CITY OF *Sunfish Lake* MINNESOTA

**Planning Commission
Findings of Fact &
Recommendation
(Approval)**

Request: The applicants request City approval of major site and building plans at 393 Salem Church Road.

PLANNING REPORT - Major Site and Building Plan Review

4 DRYSTACK GRAVITY WALL SECTION

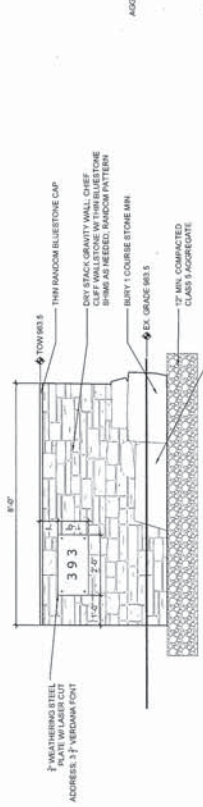
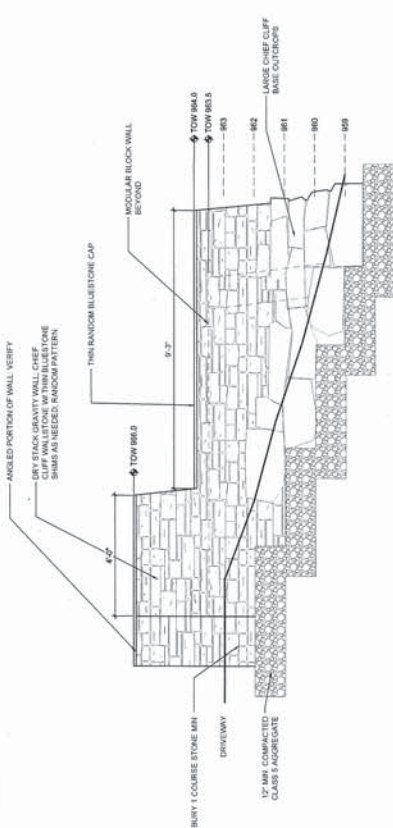
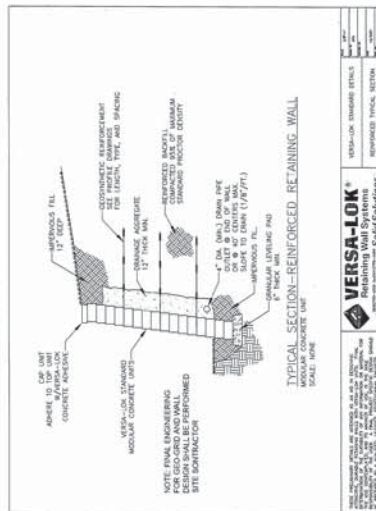
The applicant is proposing several retaining walls as part of the project, some of which are four feet in height or taller. The City Engineer has indicated that these retaining walls need to be designed and signed by a registered professional engineer, and the plans provided to the City Engineer for review prior to the issuance of a final building permit.

The applicant's proposed site grading shows a positive slope away from the house foundation, therefore, should require no modifications to the proposed grading plan. The applicant is proposing retaining walls as part of the project, some of which are 4 feet in height or taller and will need to be designed and signed by a registered professional engineer in the State of Minnesota. These plans will need to be provided to the City Engineer's office for review before final building permit is issued.

- a) Extend protective fencing around the primary drain field.
 - b) Structural calculations from a registered engineer in the State of Minnesota will be required for retaining walls that exceed four feet in height. A copy of these plans needs to be provided to the engineer office before the work on the wall can proceed.

EROSION CONTROL /
DEMO PLAN

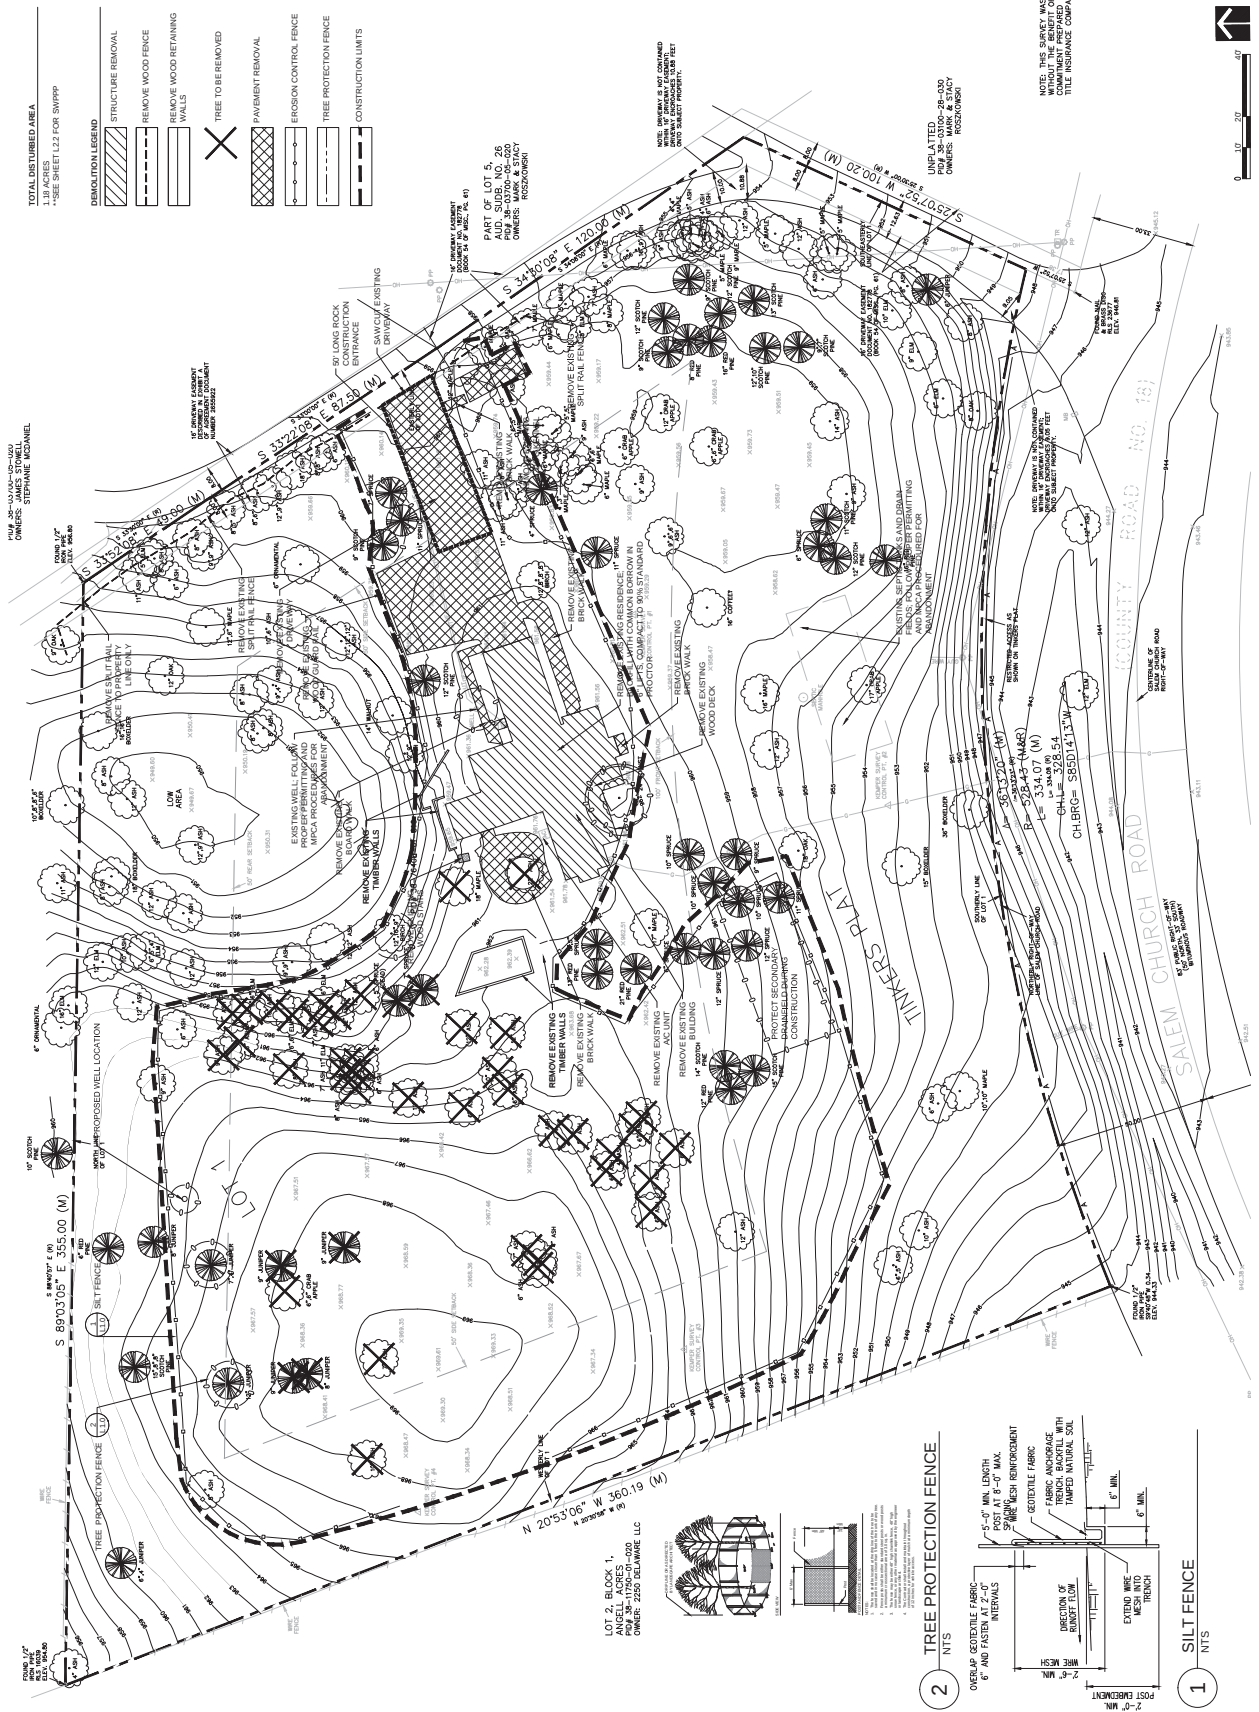
The City Engineer is providing recommendations for site erosion control measures as outlined in his report (see Exhibit M). Specifically, he has requested that the applicants provide a revised demolition and erosion control plan illustrating that silt fence will be extended around several trees to be removed at the northwest corner of the graded site, as well as to encompass the proposed secondary drain field area, existing and proposed well locations, and existing septic areas to be removed (if this is the case). The intention is to protect these areas from destruction or soil compaction during the course of construction. The total area disturbed calculations provided on the erosion control plan will need to reflect this new extent of silt fencing.

Site silt fence must be extended around the ash and elm trees that are to be removed on the north west corner of the proposed graded site. The total area disturbed calculations must be modified to include this area. The applicant will need to place, either silt fence or orange construction fence, around the proposed secondary drain field to prevent destruction and/or soil compaction of these areas during construction. Also, if the applicant is proposing to remove the existing septic drain field and tanks. Silt fence must be extended around any of these areas that will require excavation for removal and the site erosion control plans should be revised to show these changes. The removal of these septic systems shall be in accordance with the MPCA requirements which require the top to be removed, tanks pumped, and the bottom concrete flushed, and filled with sand to allow drainage to migrate through the old septic tank. The applicant also has the option of totally removing and properly disposing of the tank which is at their option.

- 1.) Extend protective fence around Primary drain field.
- 2.) Structural calculations from a registered engineer in the State of Mn. Will be required for the wall since the total height exceeds 4 feet. A copy just needs to be provided to the engineer office before the work on the wall can proceed.
- 3.) Infiltration and or retention needs to be developed and incorporated into the final drainage plans for the 0.19 acres of new impervious surface. (345 cubic feet of retention)
- 4.) Silt fence needs to be adjusted to encompass all tree planting areas.
- 5.) Silt fence needs to be added around the proposed septic tank removal area.

- d) Silt fence needs to be adjusted to encompass all tree planting areas.
 - e) Silt fence needs to be added around the proposed septic tank abandonment area.
